PLANNING AND DEVELOPMENT SERVICES STAFF REPORT

For Planning Commission Meeting of September 7, 2016

**SUBJECT: Circle K Site Plan for City Council Approval
(1420 East Stadium Boulevard)
File No. SP15-014**

**SUBJECT: Circle K Site Plan for City Council Approval
(1420 East Stadium Boulevard)
File No. SP11-037**

SHEET TITLE:
SITE LAYOUT PLAN

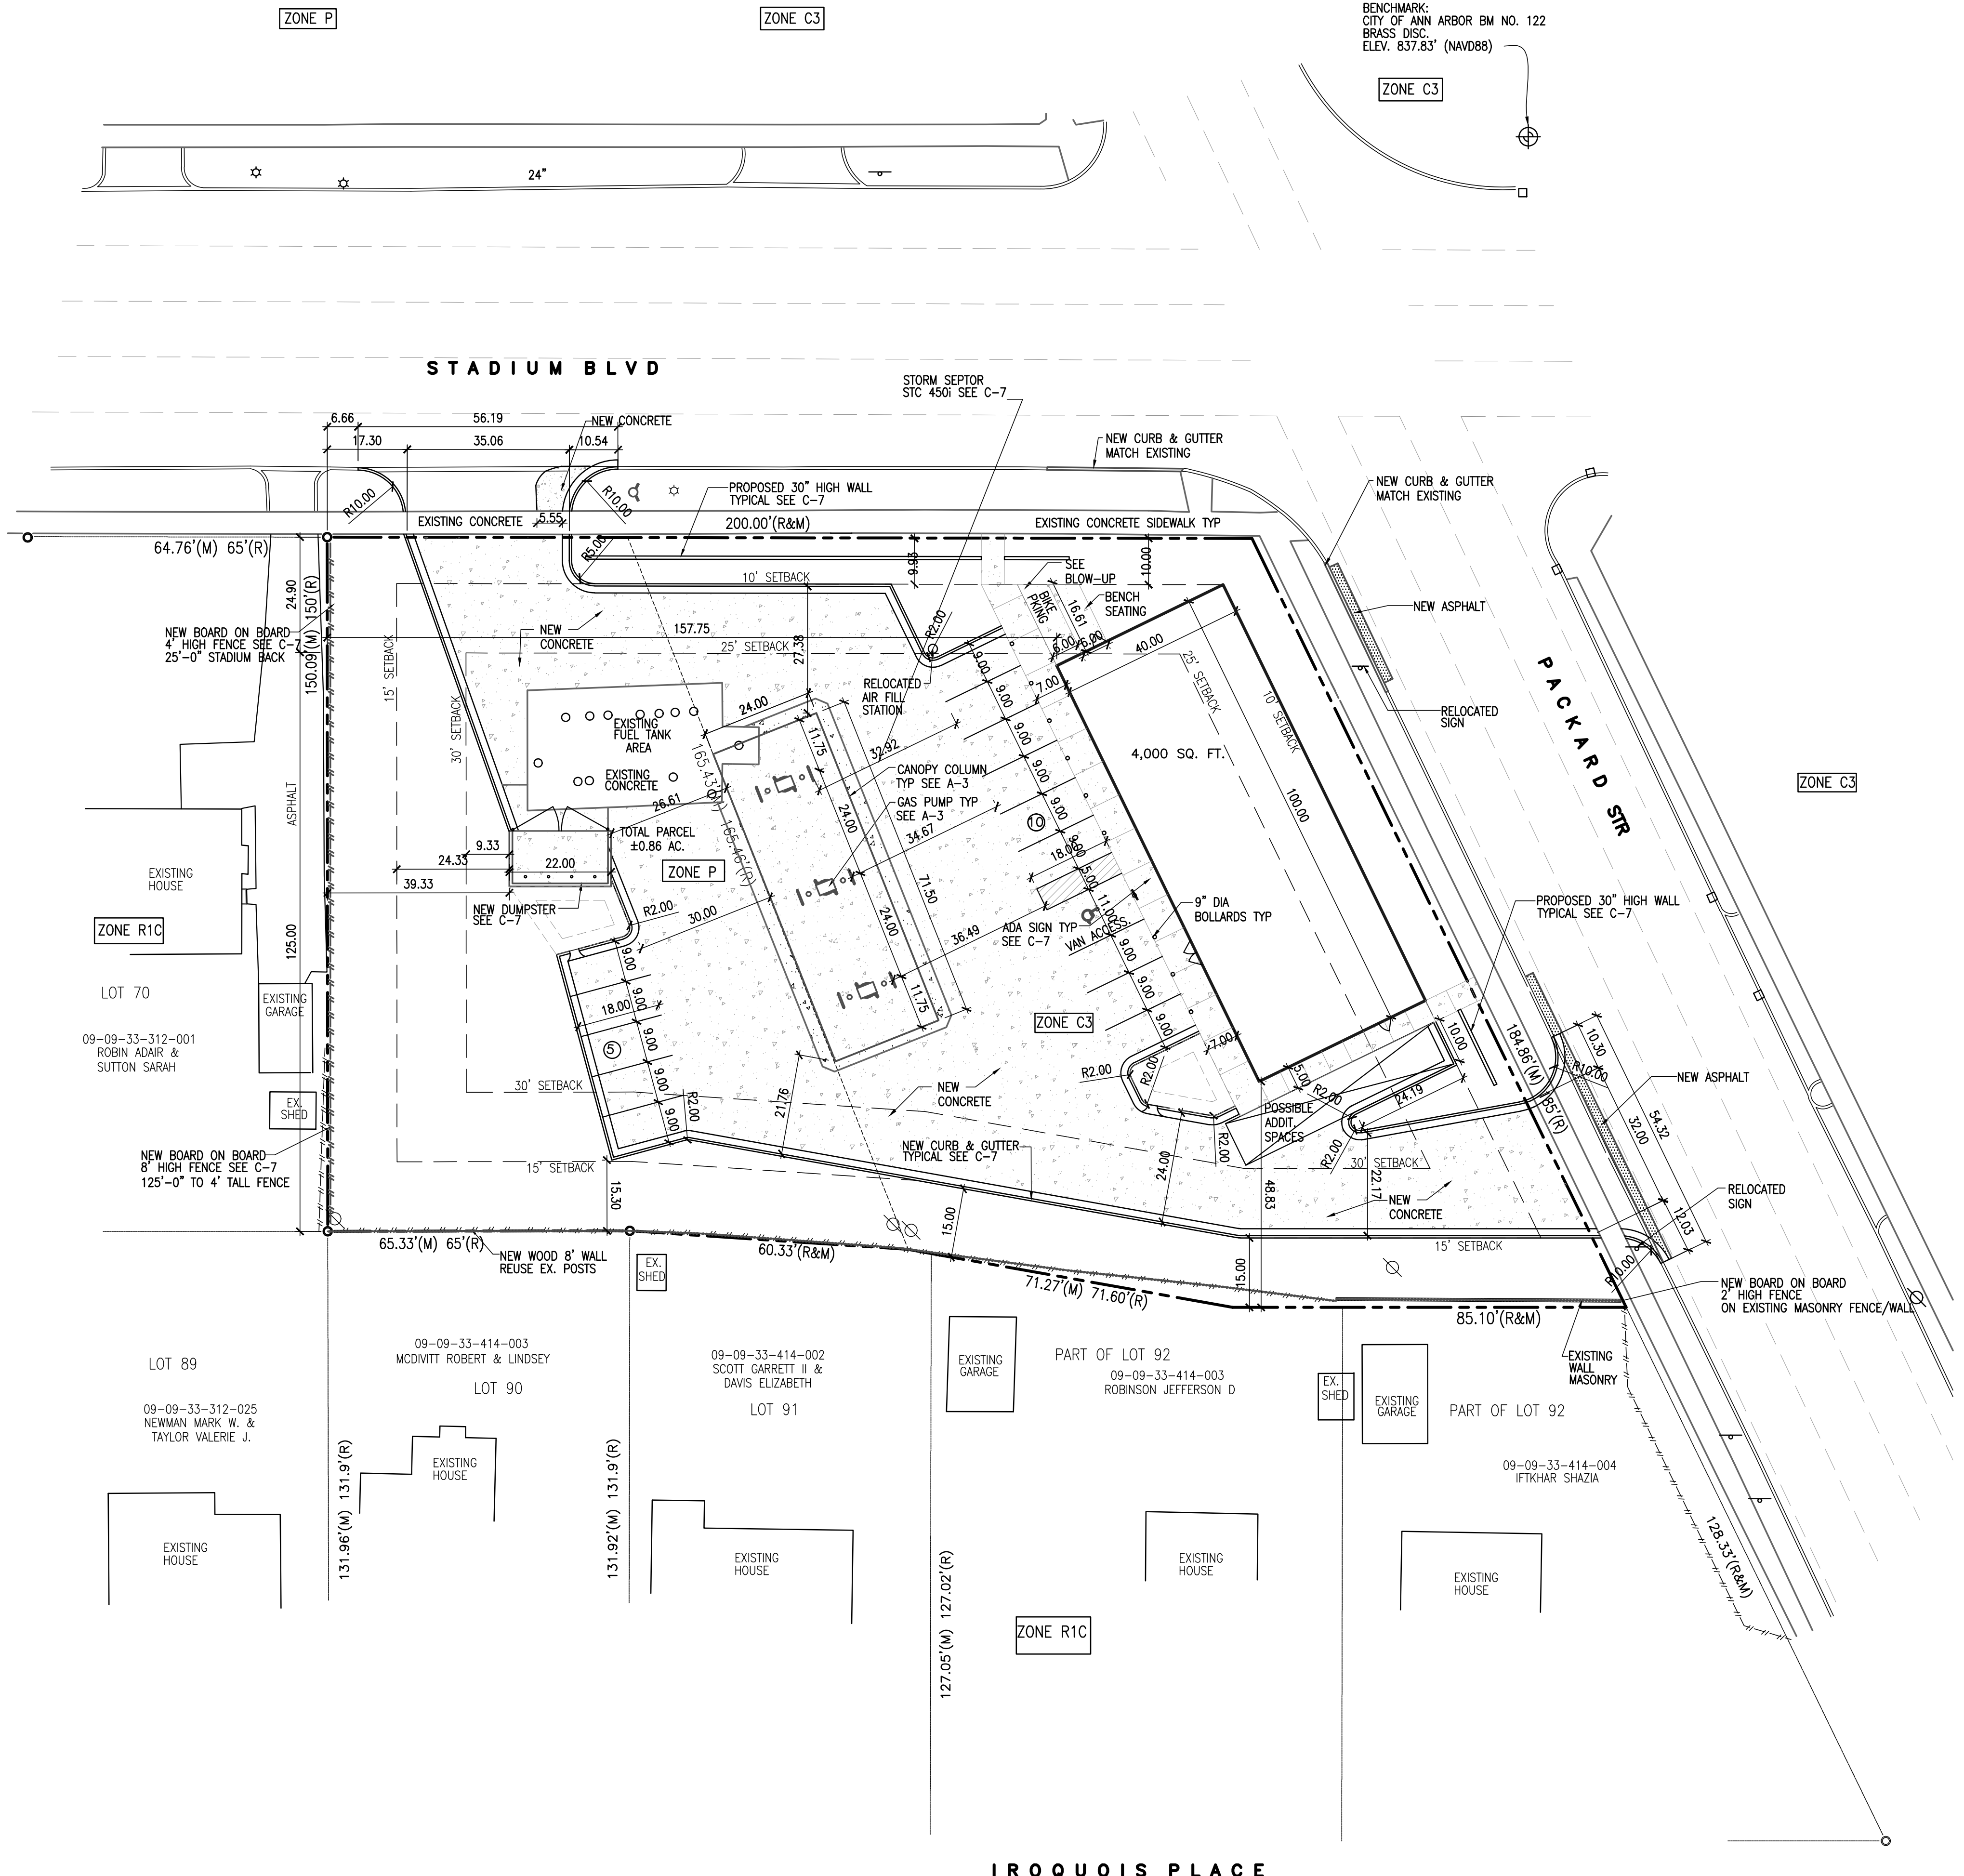
This site plan was postponed at the March 15, 2016 Planning Commission meeting in order to allow the petitioner time to address concerns mentioned by the Planning Commission. These concerns included: the location of the building within the rear setback (variance required), site lighting, canopy structure, and the driveway proximity to the intersection of Packard and West Stadium intersection.

The site plan as proposed requires that variances for both driveway widths be granted from the Zoning Board of Appeals (ZBA). The drives are designed wider than the maximum required width in order to allow for solid waste and gasoline tanker trucks to enter the site safely and most efficiently. Due to the unique constraints of the deed restriction for the western third of the site, vehicle circulation and the requirement for employees to have direct eye contact with the gas pumps, the petitioner feels the proposed site plan is the best to minimize impacts, including light pollution, to the neighborhood and address Planning Commission concerns.

Systems Planning (Landscaping) – It appears several trees adjacent to the southern property line could be saved through construction. Preservation of these trees would also align with some requests of some adjacent property owners. While the petitioner has shown the required mitigation for these trees, if the trees are saved, the overall mitigation required would be reduced accordingly.

The petitioner has responded by redesigning the site and moving the building toward the corner of Packard and East Stadium, utilizing the 10 foot minimum setback along Packard. As a result, the driveway to Packard has been shifted to the south, away from the intersection. Moving the building toward the intersection also eliminated the need for a rear setback variance; however, variances for both driveway widths are still required. The number of gas pumps has been reduced by two for a total of 6 pumps. The petitioner has also revised the supplemental photometric study that was submitted. All lights on the canopy are flush with the canopy ceiling at 15 feet in height. The canopy has a three foot high fascia that wraps the canopy and extends one foot below the height of the lights to provide additional screening.

SHEET TITLE:
SITE LAYOUT PLAN

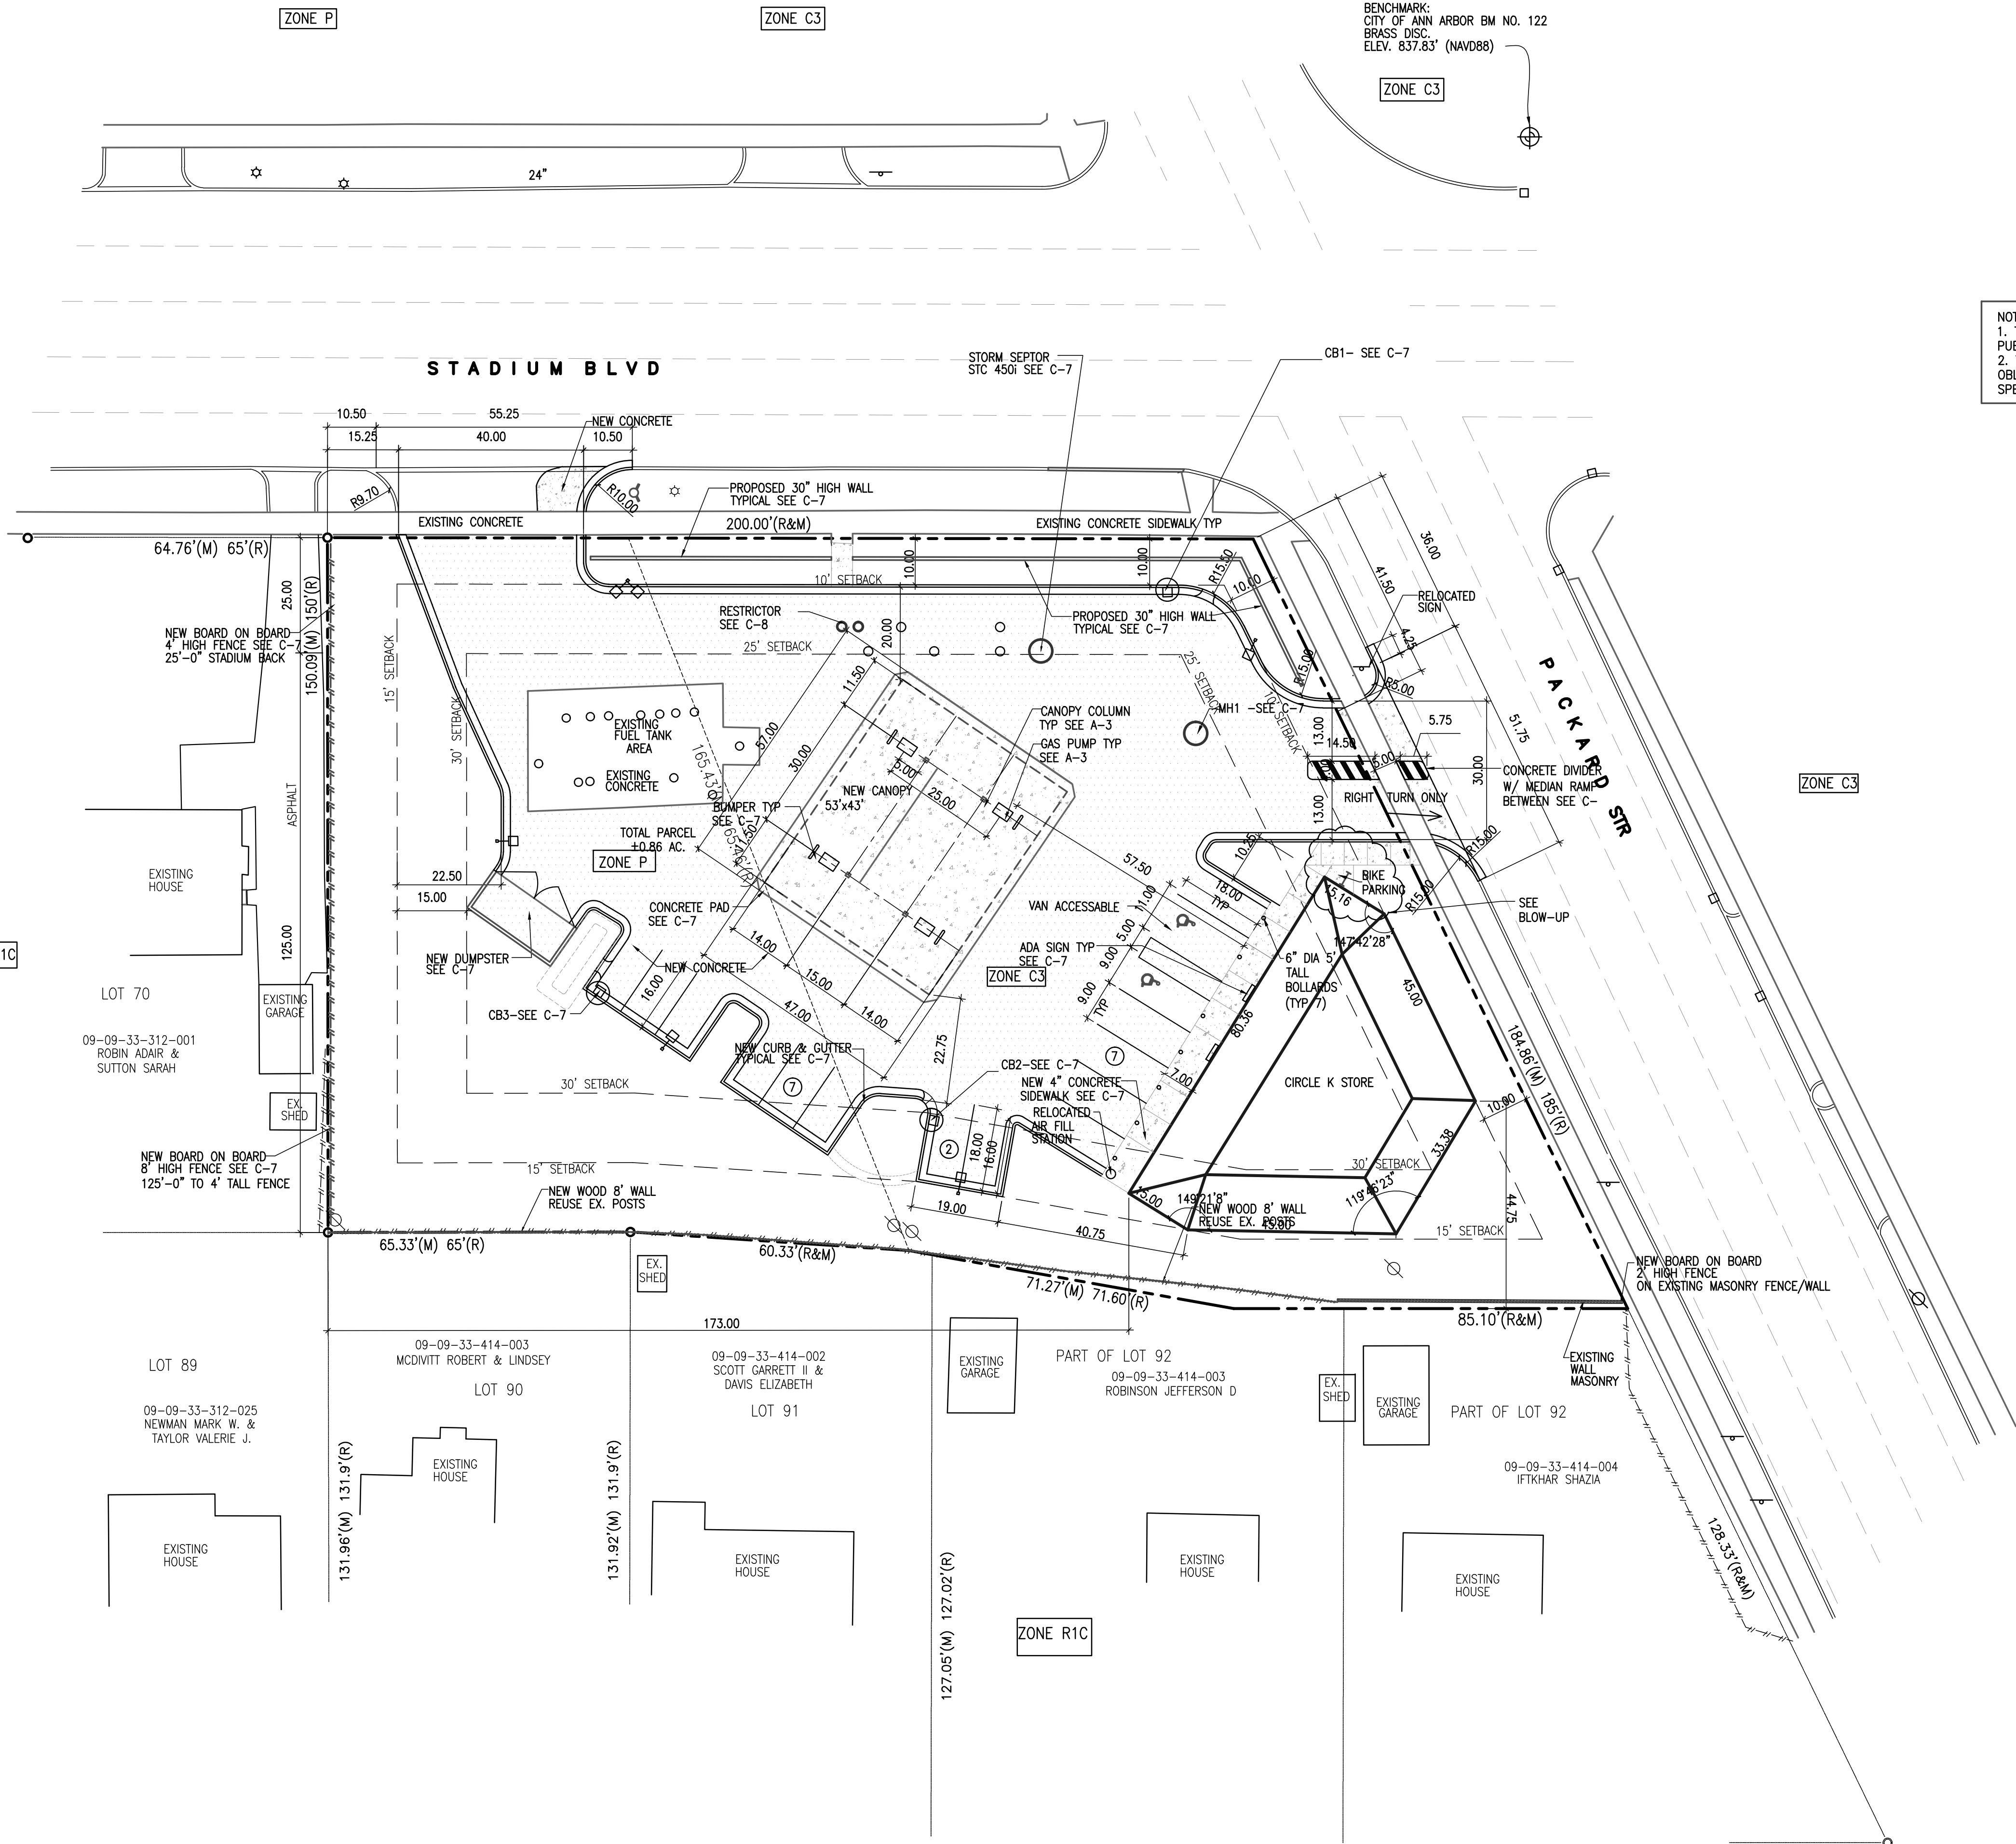
Systems Planning (Engineering) – Sanitary mitigation calculations require revisions. The final mitigation amount required(if any) is pending, additional information is required.

Systems Planning (Landscaping) – Several plants within the bioretention areas shall be replaced with salt tolerant species.

Systems Planning (Soil Erosion and Stormwater) – Minor revisions are needed to the grading plan in order to ensure proposer drainage to the bioretention areas as well as proper overflow to the storm catch basins on the site.
